From: Katie Jones [kjones@riceswd.com]
Sent: Thursday, March 03, 2011 4:04 PM
To: Hansen, Edward J., EMNRD
Cc: Hack Conder; Katie Lee
Subject: Hobbs C-30 vent (1R428-54) CAP Addendum
Attachments: Hobbs C-30 vent Proposed liner.pdf

This email is an Addendum to the Hobbs C-30 vent site (1R428-54) Corrective Action Plan, submitted to the NMOCD on December 3, 2010. Page 4, section: Recommendation, paragraph 2: text in blue lettering, below, will be added to the paragraph. Red lettering marked with a strike-through will be deleted. The new Plate 2 showing the proposed liner location is attached. If you need any further information, please let me or Hack know.

RE: **Rice Operating Company, Hobbs SWD System C-30 Vent Site: T-18-S, R-38-E,
Section 30, Unit C, Lea County, New Mexico, (NMOCD CASE #1R428-54),
Corrective Action Plan**

Plate 2

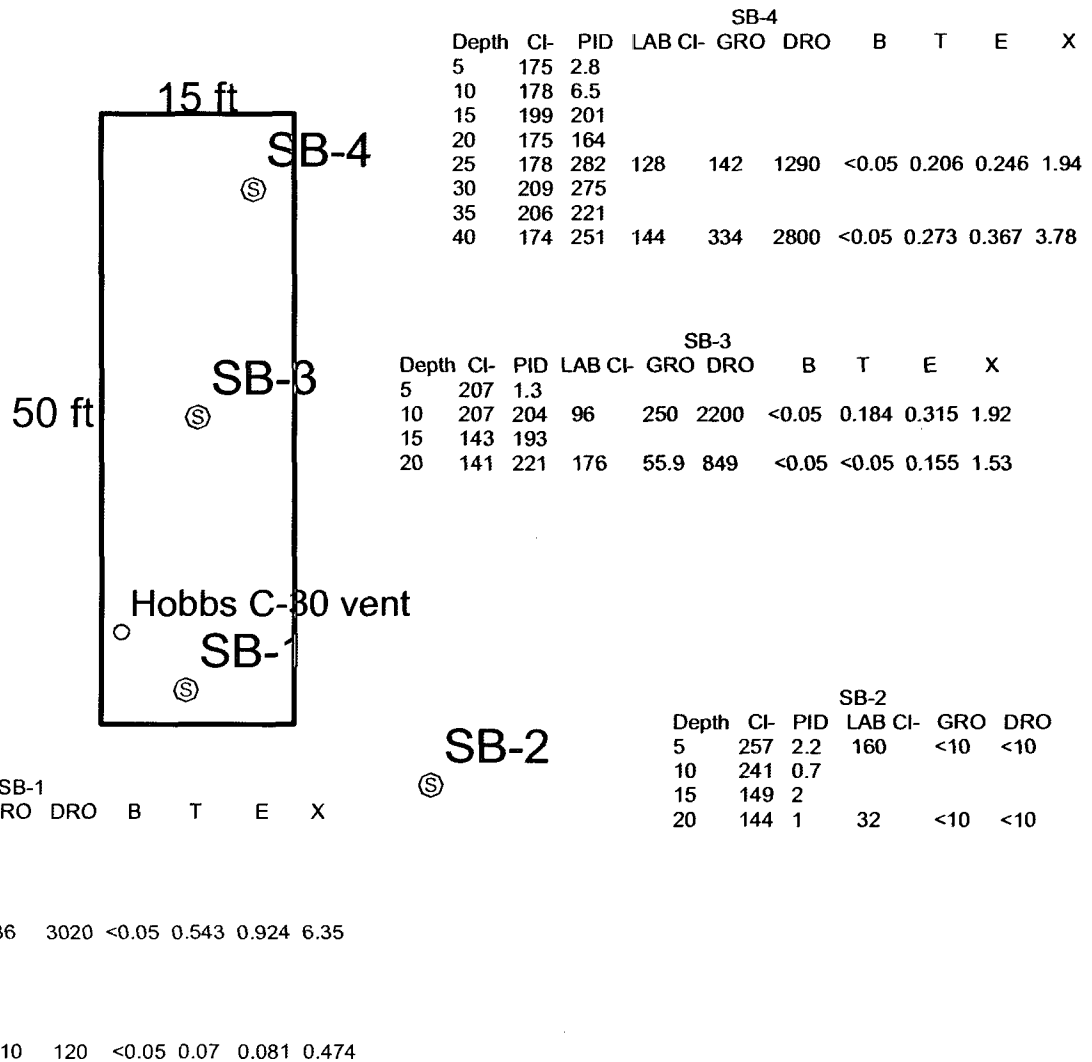
“Our recommended corrective action for the site is the installation of a 750 square foot synthetic liner approximately 4 feet below ground surface over the former site and re-vegetation of the ground surface. This proposed remedy will limit infiltration of precipitation and the subsequent migration of constituents of concern to ground water. As part of this effort, ROC plans to:

- ~~Scrape and remove large rocks and caliche,~~
- ~~Backfill the site with soil blended with amendments~~
- Install a synthetic liner approximately 4 feet below ground surface. This liner will be positioned over the locations of SB-1, SB-3 and SB-4 (See Plate 2). The liner will be 15 feet wide and 50 feet long.
- Evaluate excavated soil for use as backfill. Any soils requiring disposal will be properly disposed of at a NMOCD approved facility.
- Backfill the area over the liner with soil containing a chloride concentration of less than 500 mg/kg and a PID (field) reading of less than 100 ppm.
- Make sure the area is free of large rocks and caliche, and amend and grade soil at the site to match surrounding area grading.
- Broadcast seed by hand,
- Set up silt net fencing to protect new vegetation and inhibit erosion.

A synthetic liner installed below the root zone as proposed will inhibit the downward migration of water through the subsurface, slowing movement of chloride or soluble hydrocarbons toward ground water. Plants capture water through their roots, thereby reducing the volume of water infiltrating below the root zone. This natural “infiltration barrier” also helps protect ground water. Upon documentation of installation of the liner and re-seeding with an appropriate mix of native grasses we will submit a Termination Request for this site’s regulatory file.”
